ADDENDUM #2

PROJECT: Site Work for Barnyard Ride PROJECT #: 22433

OWNER: City of Aberdeen Parks, Recreation and Forestry Department

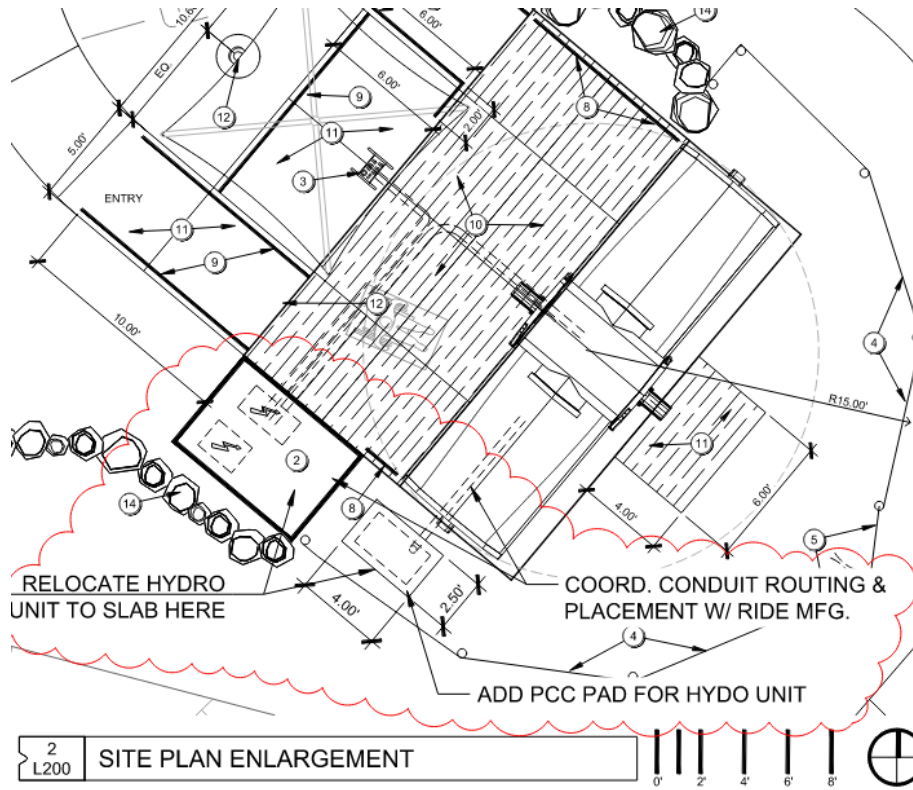
Sheet L200. Add 5" thick concrete pad for hydraulic unit.

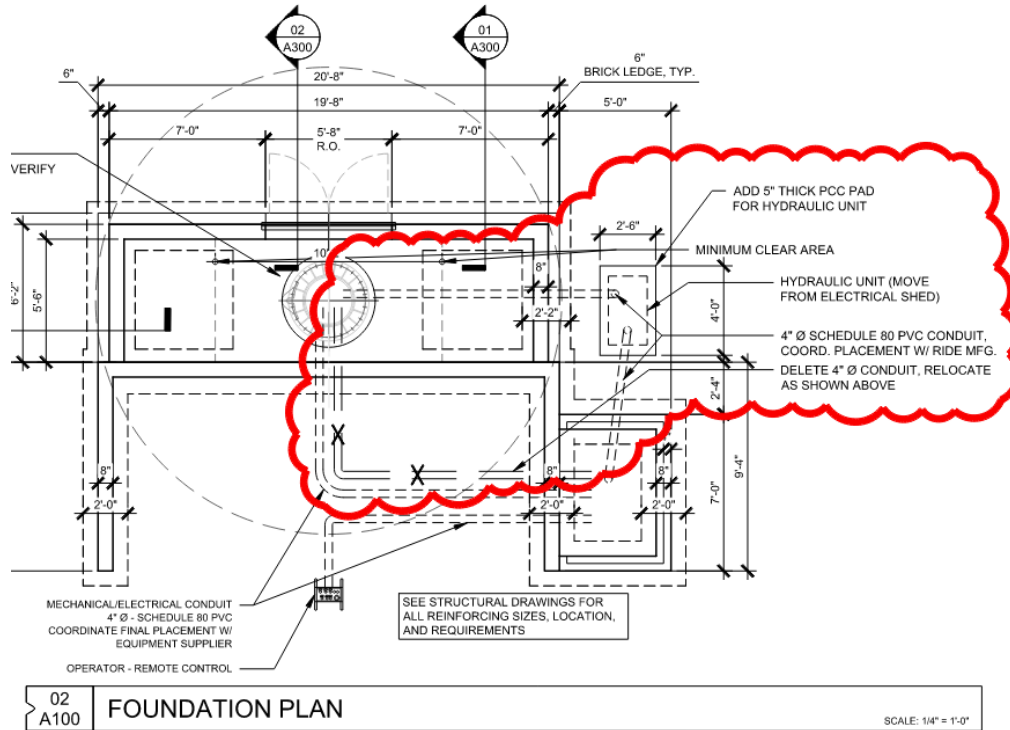
Sheet A100. Hydraulic unit for ride to be located outside of shed due to clearance requirements.
